**Summary of Submissions**  
**Lot 33 (681) Hopkinson Road, Cardup – Structure Plan – PA22/957**

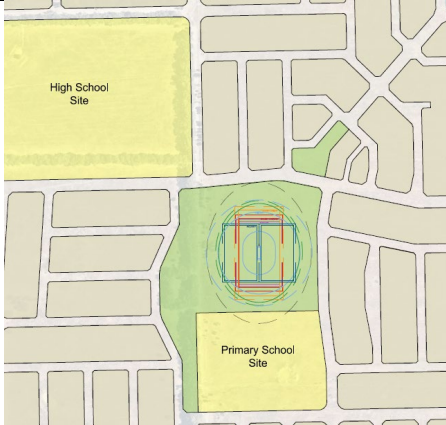
Submitter	No	Submitter Comments	Applicant Comments	Shire Comments and Recommendation
		<p>budget and outcomes of future community consultation exercises. The proposed route would travel from the future Byford train station, approaching the Structure Plan site from the north and then passing through to the south of the site.</p> <p>To ensure the effective provision of bus services, the PTA would like to provide comment on issues identified in the proposed Structure Plan.</p> <p><u>Provision of ‘Neighbourhood Connector’ Roads</u></p> <p>While the Structure Plan includes the provision of several ‘Neighbourhood Connector’ roads, the proposed road network would not allow bus services to travel through and pass out at the southern end of the development exclusively using ‘Neighbourhood Connector’ roads. Should residential development occur further south of the Structure Plan site in the future, this would compromise the PTA’s ability to provide effective and legible bus services to the broader locality outside of the proposed Structure Plan area.</p> <p>The PTA requests that consideration be given to amend the Structure Plan to extend the ‘Neighbourhood Connector’ road that is proposed adjacent to the south of the proposed ‘Primary School’ reserve site, to connect to the ‘Integrator Connector’ road. Alternatively, should this outcome not be achievable, consideration should be given to ensure sufficient road width to accommodate dual operation bus movements on this road.</p> <p>Figure 1 – Neighbourhood Connector Roads highlights the areas of reference in red.</p>	<p>7.0-metre road carriageway to support dual bus movements. The likely bus route, as discussed with the Public Transport Authority, is identified below:</p>  <p>The following identifies the current road carriageway widths for the potential route:</p> <ul style="list-style-type: none"> <li>• Road 1 is a Neighbourhood Connector B classification with a 7.4-metre carriageway;</li> <li>• Road 2 is an Access Street B classification with a 5.5-metre carriageway;</li> <li>• Road 3 is an Access Street B classification with a 5.5-metre carriageway; and</li> <li>• Road 4 is Access Street C classification with a 7.2-metre carriageway.</li> </ul>	<p>allow bus services to travel through and pass out at the southern end of the development exclusively using ‘Neighbourhood Connector’ roads. The PTA have recommended that the road to the south of the primary school site that links to the Integrator Connector at the eastern boundary of the structure plan area be identified as a Neighbourhood Connector to accommodate buses.</p> <p>Officers note that the proposed structure plan map shows Neighbourhood Connector roads surrounding the primary school site and the public open space, however the Transport Impact Assessment and Section 3.5.2 of Part 2 of the structure plan shows the eastern, western and southern roads all to instead be classified as an Access Street B.</p> <p>To accommodate bus movements in accordance with Liveable Neighbourhoods, officers agree that the roads to the west and south of the primary school site and district open space would</p>

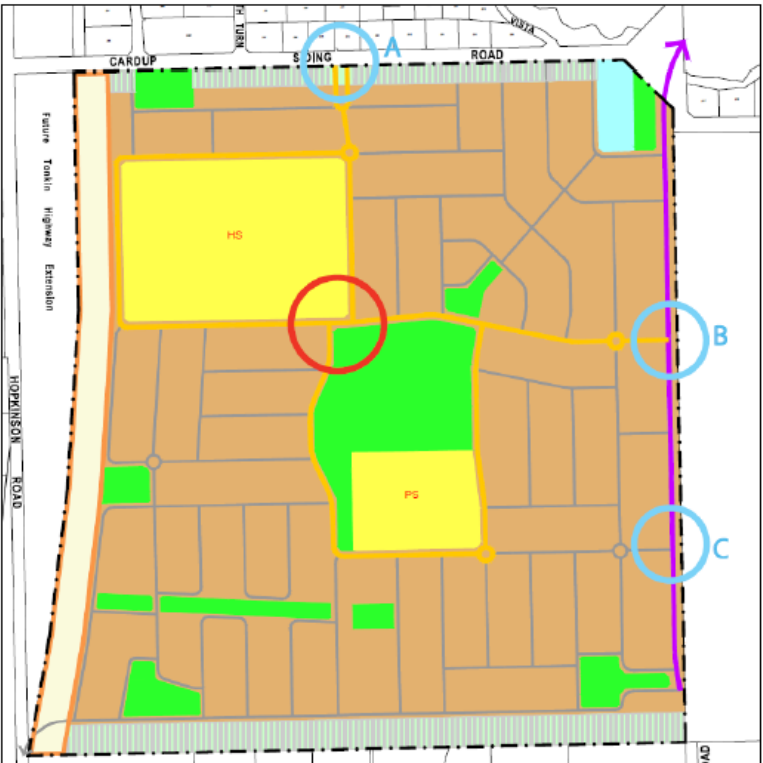
Submitter	No	Submitter Comments	Applicant Comments	Shire Comments and Recommendation
		 <p><i>Figure 1 - Neighbourhood Connector Roads</i></p> <p><u>Unprotected Right Turns</u></p> <p>Unprotected right turns at the very least delay bus services and increase journey time for passengers. In the worst instances, unprotected right turns result in serious safety concerns that may restrict the operation of bus services.</p> <p>The lack of a direct and straight road through the Structure Plan site will likely result in a situation that requires buses to undertake unprotected right turns, to operate on an alignment that provides sufficient walkable catchment to bus services, a key effectiveness indicator for the PTA.</p>	<p>The request for additional neighbourhood connectors is not justified based on traffic volumes. However, our Client will provide the minimum road pavement width to support dual bus movements for Road 2 and Road 3 as part of the subdivision process.</p> <p><b>Movement network - Unprotected Right Turns (internal)</b></p> <p>The alignment of the north-south connector roads, as identified by the red circle, has been offset to ensure the retention of the windrows that define Lot 33, as identified below on the concept plan:</p>	<p>need to be identified as Neighbourhood Connector roads.</p> <p><b>Unprotected Right Turns</b></p> <p>It is noted that the Public Transport Authority have raised concern with the unprotected right turns at the south-east intersections of the high school with the District Open Space. The applicant has stated that the alignment of the north-south roads in this location have been located to protect the windrow trees, which are a defining character element of the site. Shire officers recognise that the retention of the windrow trees promotes tree canopy coverage and provides a sense of place, however also acknowledge that the proposed intersections at this location and unprotected right turns creates a traffic safety issue.</p> <p><b>Bus Embayments</b></p> <p>It is noted that the PTA requires the provision of bus embayments to facilitate the operation of bus services. Shire officers support the provision of bus embayments.</p>

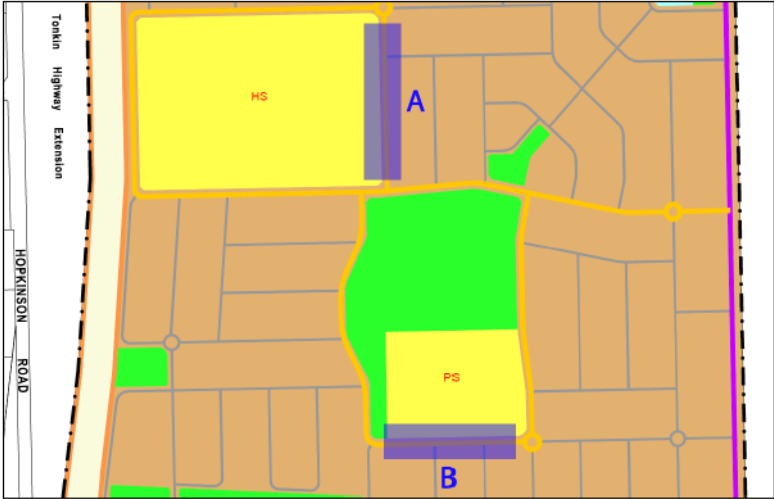
Submitter	No	Submitter Comments	Applicant Comments	Shire Comments and Recommendation
		<div style="text-align: center;">  <p style="font-size: small;">Figure 2 - Unprotected Right Turns</p> </div> <p><b>Provision of Bus Embayments</b></p> <p>The PTA would like to highlight the need for the provision of a bus embayments to facilitate the operation of bus services to service the Structure Plan area.</p>	<p style="text-align: center;">(Page 30)</p> <p><b>Movement network - Unprotected Right Turns (external)</b></p> <p>The <i>Byford District Structure Plan</i> identifies Bett Road (south) as a district distributor and in <i>Perth and Peel @3.5 million Frameworks</i> as a proposed regional road on the eastern boundary of the Structure Plan.</p> <p>The design of Bett Road (south) as an Integrator B road can accommodate protected right-turn pockets in the future medians. The provision of protected right-turn pockets is supported.</p> <p>It is noted that intersection A (Cardup Siding Road) will not be required to accommodate service movements if the route below is adopted:</p>

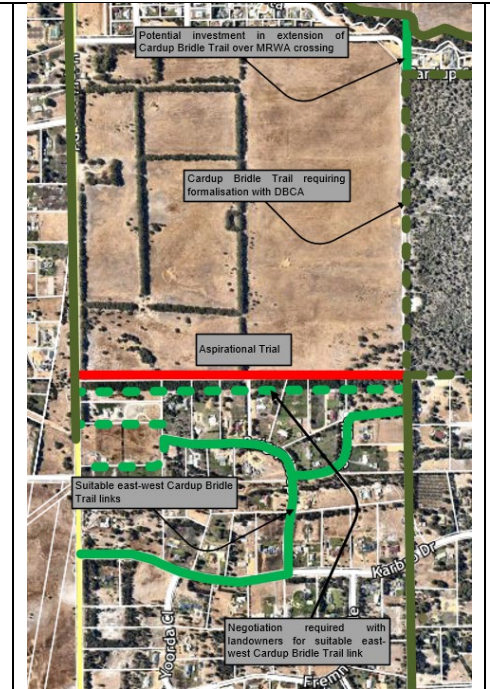
Submitter	No	Submitter Comments	Applicant Comments	Shire Comments and Recommendation
			<p>Per some public submissions, horse riders/trail users prefer to separate equestrian and residential uses. The development of Lot 33 will not remove any trails or reduce the functionality of the existing trail network.</p> <p>Our Client supports the Equine Advisory Group in identifying locations for suitable trails; Lot 33 is not a viable east-west equestrian link. The more appropriate location for a new east-west trail is in the “Special Rural” zoned land to the south of Lot 33, utilising the existing trails and creating new links as outlined below:</p>

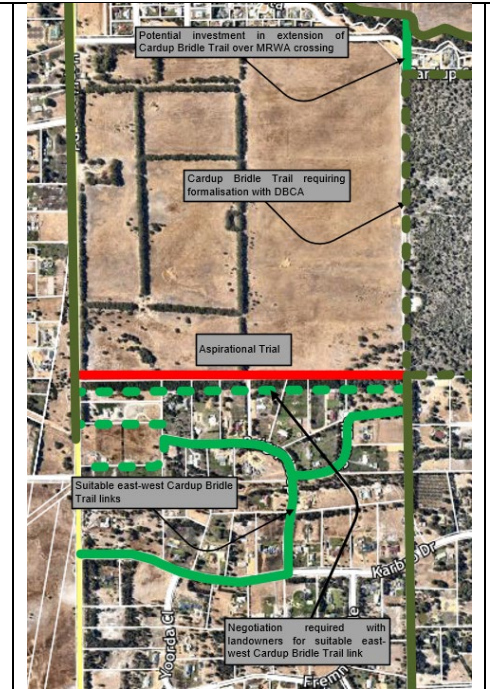
Submitter	No	Submitter Comments	Applicant Comments	Shire Comments and Recommendation
			<p>The Aspiration Trail is effectively a land use change without consultation and, based on trail specification plus site conditions, would require an area of approximately 0.95 hectares.</p> <p>The Aspirational Trail is also not identified as significant or strategic, nor is it a key action in the Equine Trails Master Plan's Implementation Plan.</p> <p>Per some public submissions, horse riders/trail users prefer to separate equestrian and residential uses. The development of Lot 33 will not remove any trails or reduce the functionality of the existing trail network.</p> <p>Our Client supports the Equine Advisory Group in identifying locations for suitable trails; Lot 33 is not a viable east-west equestrian link. The more appropriate location for a new east-west trail is in the "Special Rural" zoned land to the south of Lot 33, utilising the existing trails and creating new links as outlined below:</p>	<p>refused due to significant issues with the design.</p>

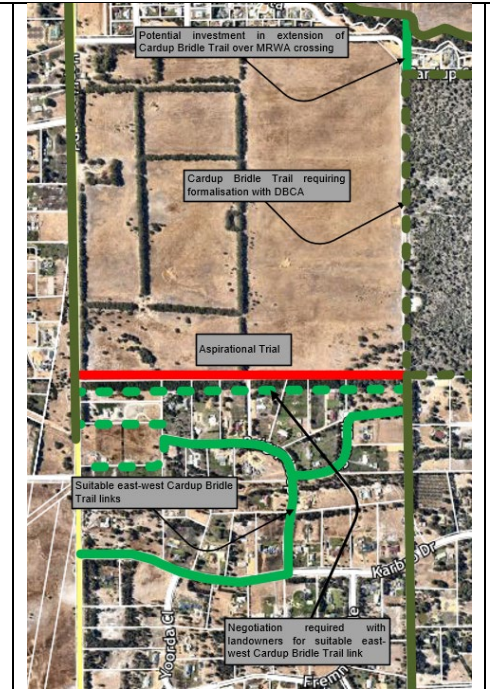
Submitter	No	Submitter Comments	Applicant Comments	Shire Comments and Recommendation
		<p>vision. Without addressing this it will ultimately impact the success of the development itself.</p>	<p>strategic, nor is it a key action in the Equine Trails Master Plan's Implementation Plan.</p> <p>Per some public submissions, horse riders/trail users prefer to separate equestrian and residential uses. The development of Lot 33 will not remove any trails or reduce the functionality of the existing trail network.</p> <p>Our Client supports the Equine Advisory Group in identifying locations for suitable trails; Lot 33 is not a viable east-west equestrian link. The more appropriate location for a new east-west trail is in the "Special Rural" zoned land to the south of Lot 33, utilising the existing trails and creating new links as outlined below:</p>

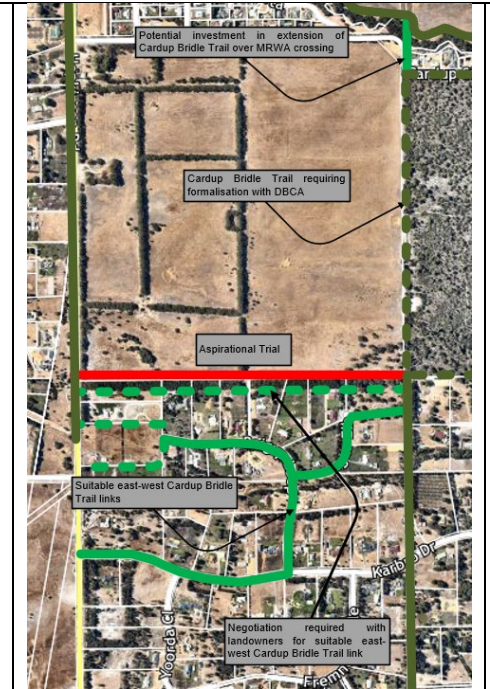
Submitter	No	Submitter Comments	Applicant Comments	Shire Comments and Recommendation
			<p>the Equine Trails Master Plan's Implementation Plan.</p> <p>Per some public submissions, horse riders/trail users prefer to separate equestrian and residential uses. The development of Lot 33 will not remove any trails or reduce the functionality of the existing trail network.</p> <p>Our Client supports the Equine Advisory Group in identifying locations for suitable trails; Lot 33 is not a viable east-west equestrian link. The more appropriate location for a new east-west trail is in the "Special Rural" zoned land to the south of Lot 33, utilising the existing trails and creating new links as outlined below:</p>
